UNITED STATES
ATOMIC ENERGY COMMISSION
WASHINGTON, D.C. 20545

Docket No. 50-219

A review of the reliability to close on demand of the main steam isolation valves (MSIVs) for the larger BWRs has been conducted. It is concluded that supplemental action is required to improve the reliability of the MSIVs to close on demand.

CORRECTIVE ACTIONS TO ASSURE
MAIN STEAM LINE ISOLATION VALVE
OPERABILITY

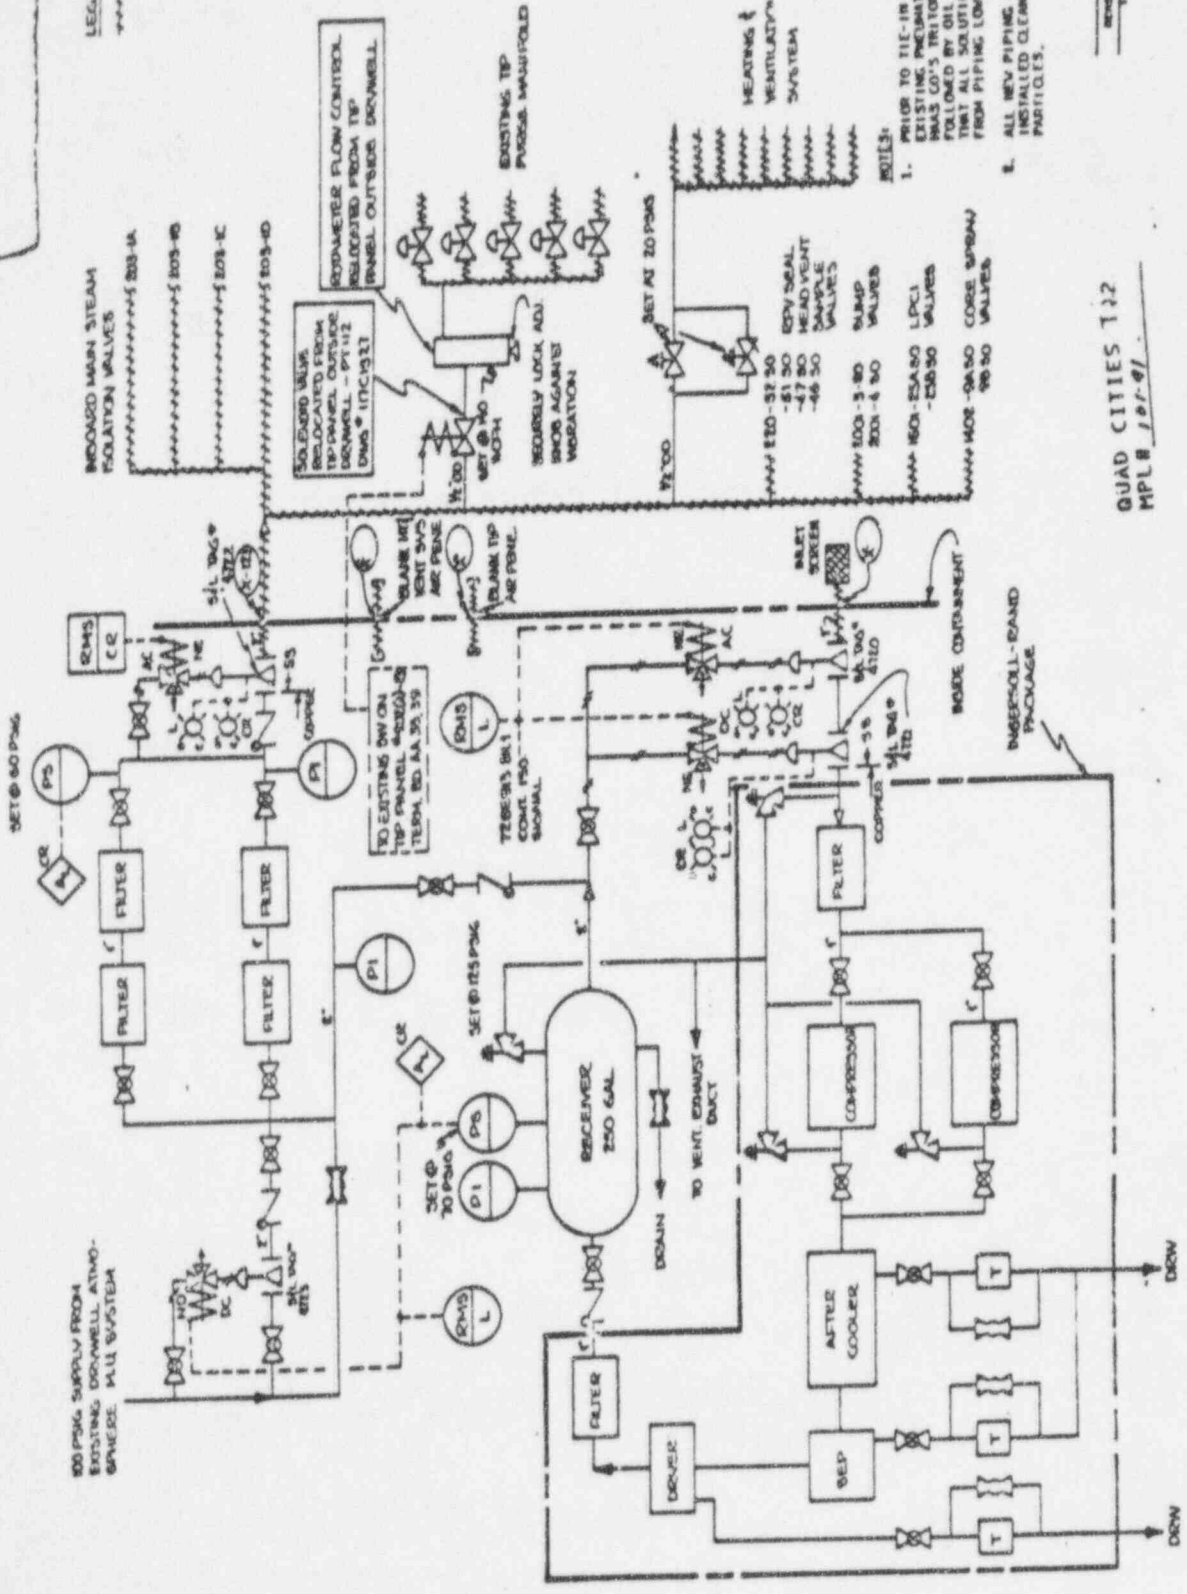
- a. The valves inside the drywell will take their supply from a pumpback system. This system consists of two air compressors, filters, separator and dryer, a 250 gallon receiver, and associated piping, valves, controls and instrumentation. The drywell pneumatic supply system takes suction from the drywell atmosphere, compresses and cleans the gas and stores it in the 250 gallon receiver at a nominal 100 psig. The receiver discharges to the equipment in the drywell which require motive gas. This system provides a source of clean gas for use in all pneumatic equipment thus limiting the effects of dirt and oil on the operation of MSLIV's. This system is being installed during the current outage. The system will be connected to the presently installed pneumatic system to supply all the equipment within the drywell requiring motive gas. The back up supply is nitrogen from the Drywell Atmosphere Make-Up System. A copy of the P&ID for the Drywell Pneumatic Supply System is attached.
